# Access Compliance Report

## Public Rights-of-Way

### (Curb Ramps)

Intersection ID: 53893	Main Street: PERTH_MOOR_RD	Cross Street: HAMILTON_BRIDGE_RD	Location: SW
ADA ID: B84AB4855D6D	Ramp Type: Perp	Initial Pass/Fail: Fail	Overall Compliance: No
Codes/Mitigation Info/Possible Solution		Field Measurements/Component Compliance

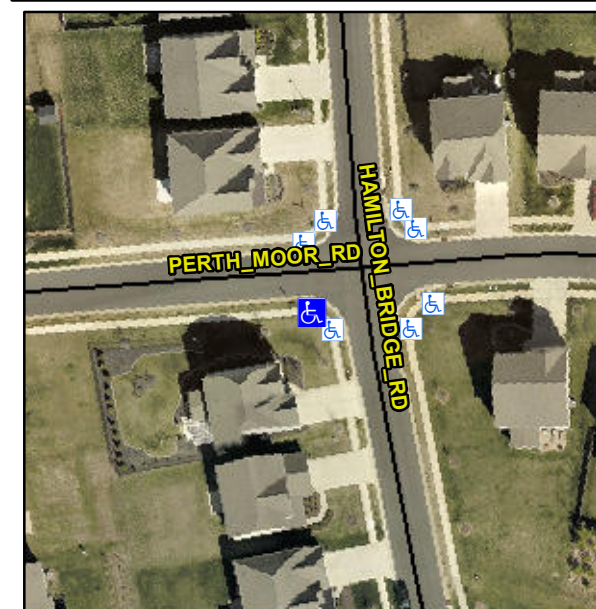
**Not Found, R304.5.1, R304.5.3**

Compliance	Description	Data	Compliance	Description	Data
N/A	Ramp Length (in)	47.0	Yes	Ramp Slope (%)	6.0
No	Ramp Width (in)	46.0	No	Ramp XSlope (%)	2.3
N/A	Flare Type LT	N/A	N/A	Flare Type RT	N/A
N/A	Flare Slope LT (%)	N/A	N/A	Flare Slope RT (%)	N/A
N/A	Flare Traversable LT?	N/A	N/A	Flare Traversable RT?	N/A
N/A	Landing Length (in)	N/A	N/A	DWS Provided?	N/A
N/A	Landing Width (in)	N/A	N/A	DWS Contrast?	N/A
N/A	Landing Slope (%)	N/A	N/A	DWS Length (in)	N/A
N/A	Landing X Slope (%)	N/A	N/A	DWS Full Width?	N/A
N/A	Landing Curb? (Y/N)	N/A	N/A	DWS Offset (in)	N/A
N/A	Shared Landing?	N/A			
N/A	Gutter Ponding?	N/A	N/A	Gutter Slope (%)	N/A
N/A	Gutter Lip Ht (in)	1.5	N/A	Gutter X Slope (%)	N/A
N/A	Painted X Walk1?	No	N/A	Painted X Walk2?	N/A
	X Walk 1 Direction	To N		X Walk 2 Direction	N/A
N/A	X Walk 1 Width (in)	N/A	N/A	X Walk 2 Width (in)	N/A
	X Walk 1 Slope (%)	0.0		X Walk 2 Slope (%)	N/A
	X Walk 1 X Slope (%)	0.7		X Walk 2 X Slope (%)	N/A

**Remove & Replace Entire Ramp.**
